ISSUE: Permit to Demolish/Capsulate (full) and Certificate of Appropriateness for alterations

APPLICANT: Russell and Michelle Shearer

LOCATION: Old and Historic Alexandria District
609 Queen Street

STAFF RECOMMENDATION

Figure 1: Existing garden wall and gate

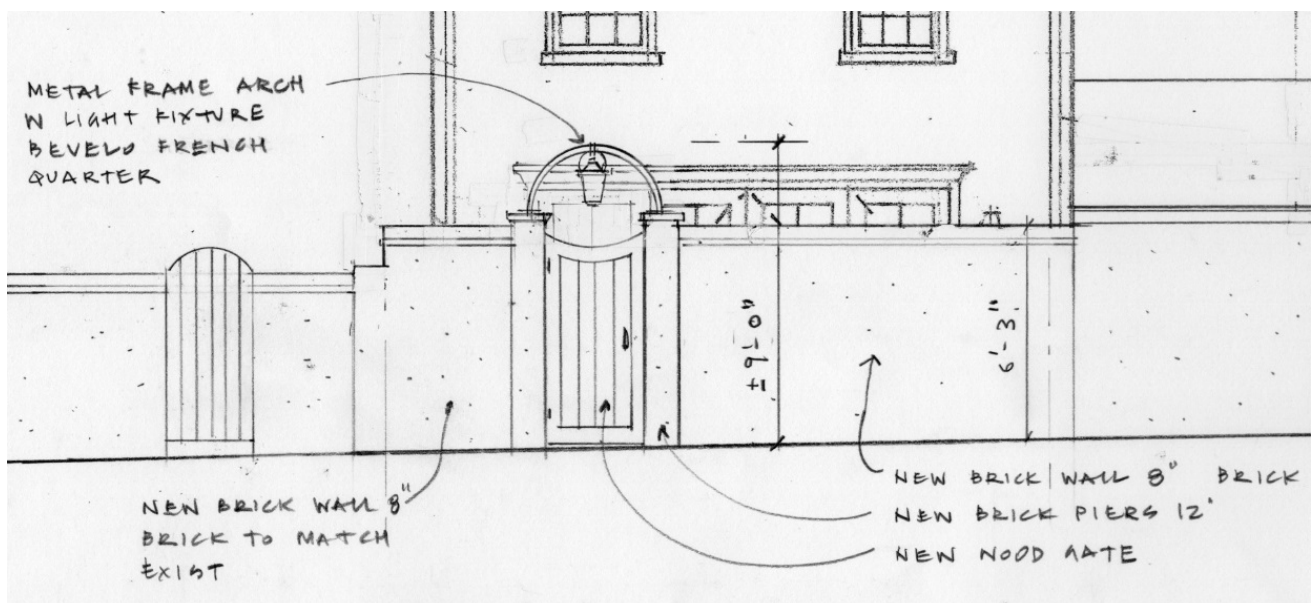
proposed wall fully complies with these guidelines. See Figure 1 for the existing wall and Figure 2 for the proposed new wall. See also Figure 3 for the wall at 611 Queen, which has a brick arch over the gate.

Staff finds the proposed wall, gate, and lighting wholly appropriate for this property, noting that the neighboring property at 611 Queen Street has a brick arch over the gate. The simple design does not overwhelm or detract from the appearance of the rear/north elevation of the house. The height of the proposed wall will better correspond to the height of the adjacent shed. The wall harmonizes with those of the other properties along the alley, and the proposed gate and light fixture provide a welcoming appearance to this entry to the property. Staff therefore recommends approval of the project, as submitted.

1 ALLEY ELEVATION — EXIST & DEMOLITION

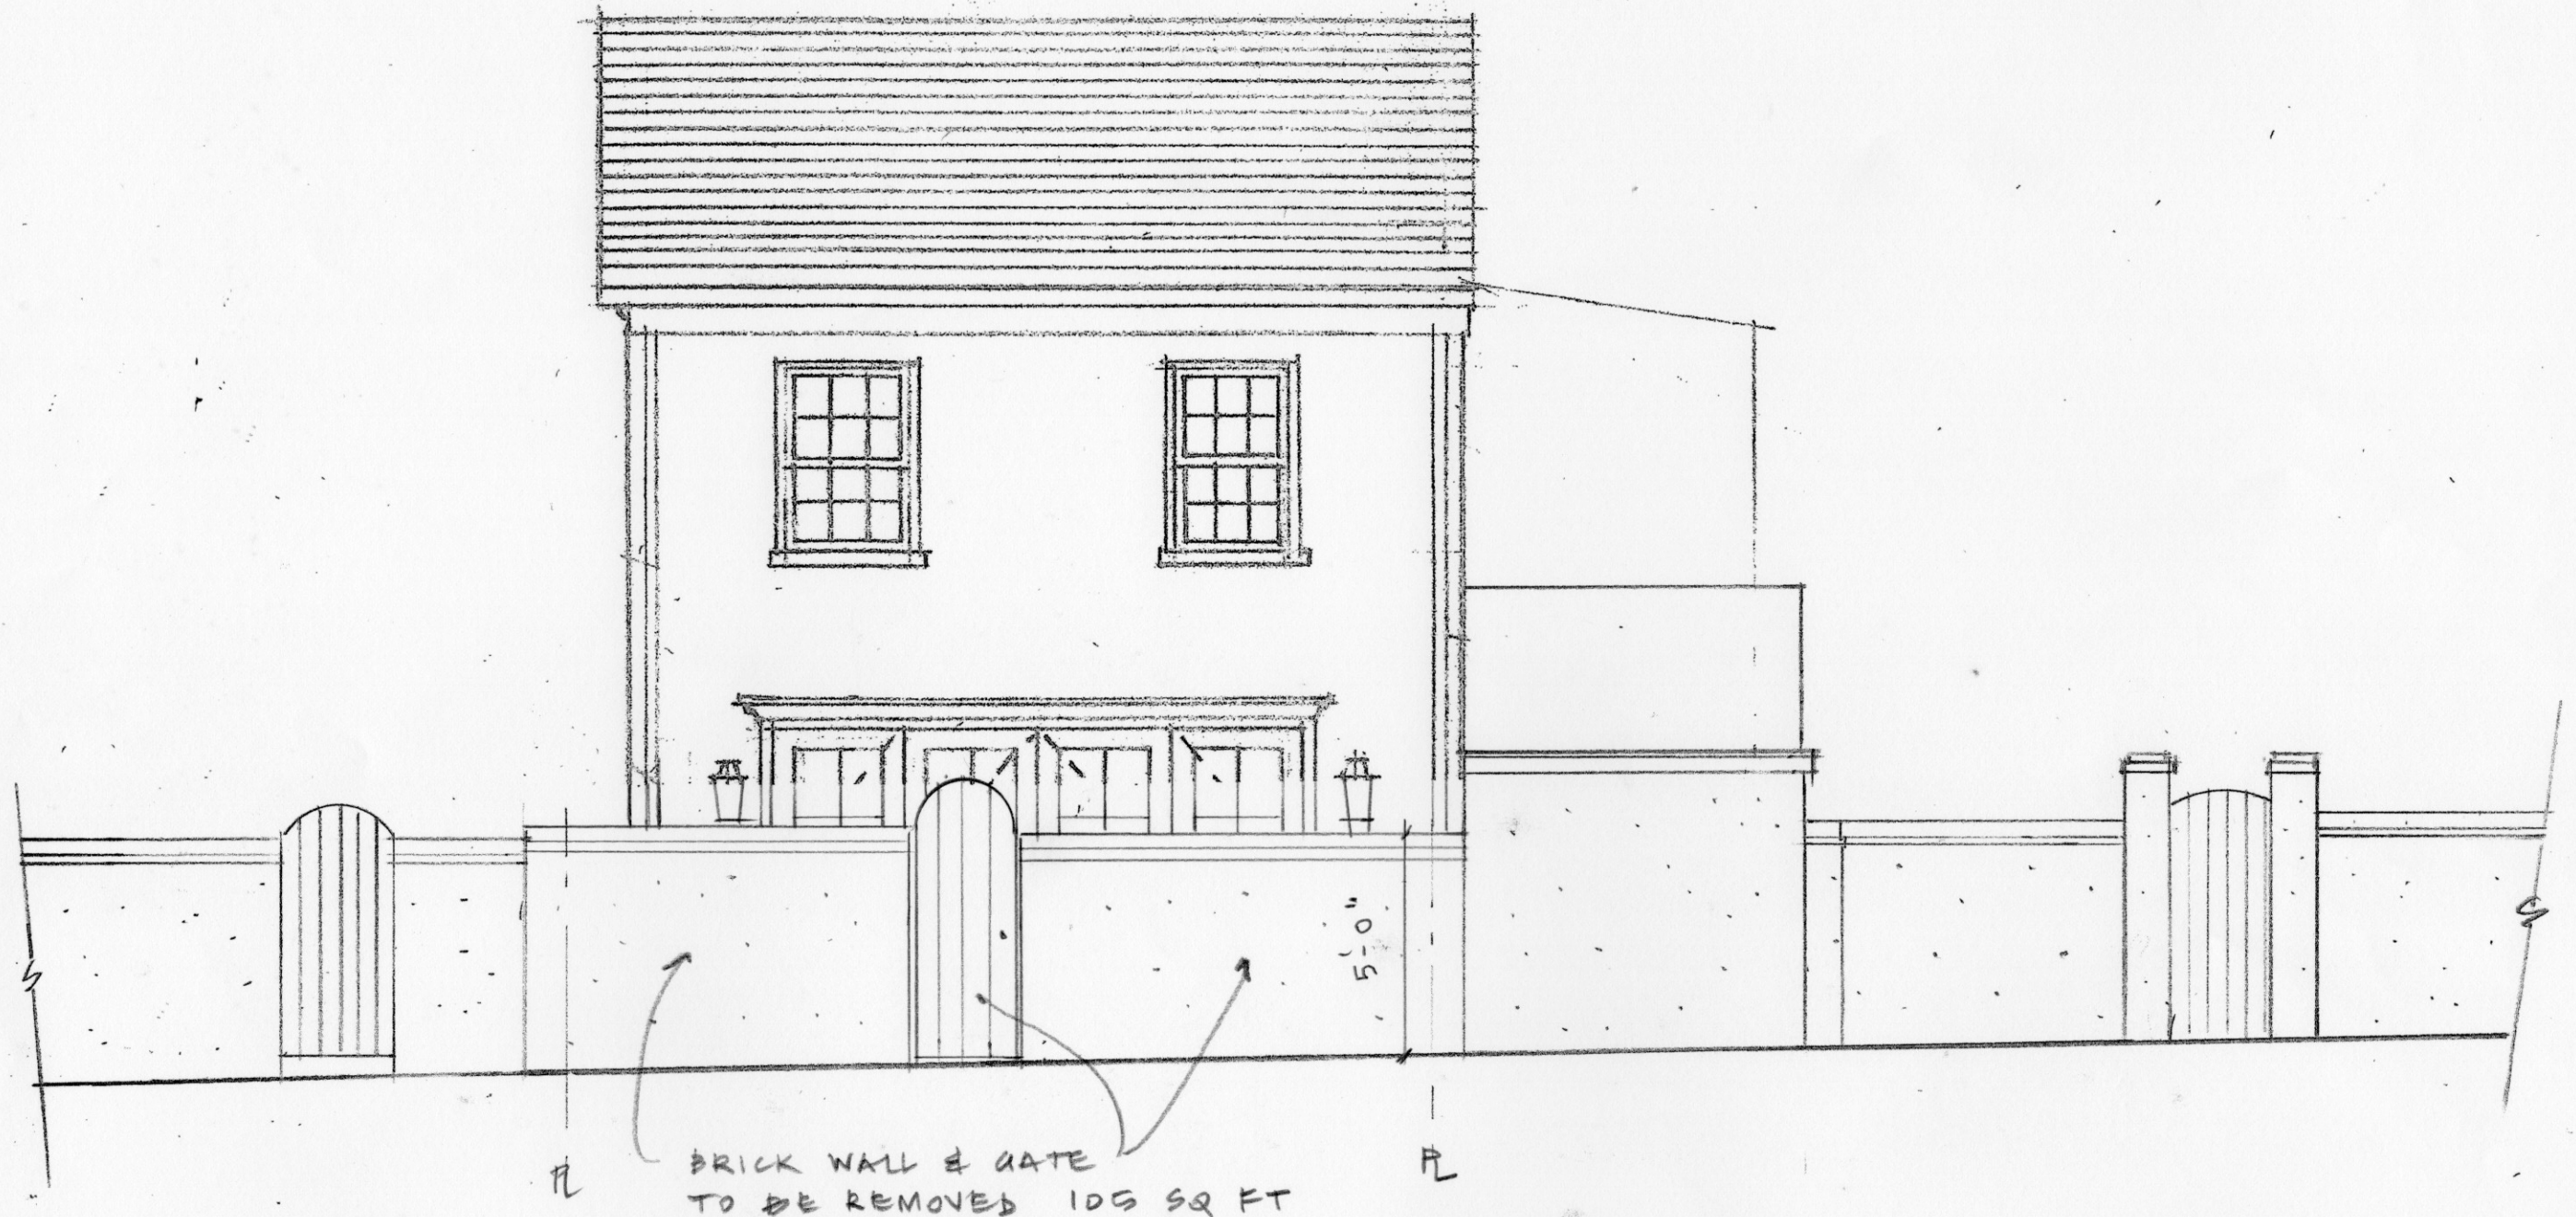
In the opinion of staff, none of the criteria for demolition and capsulation are met and the Permit to Demolish/Capsulate should be granted. The wall proposed for demolition/capsulation is not of unusual or uncommon design and can easily be replicated. The seven-course American bond brick pattern is very common throughout the country.
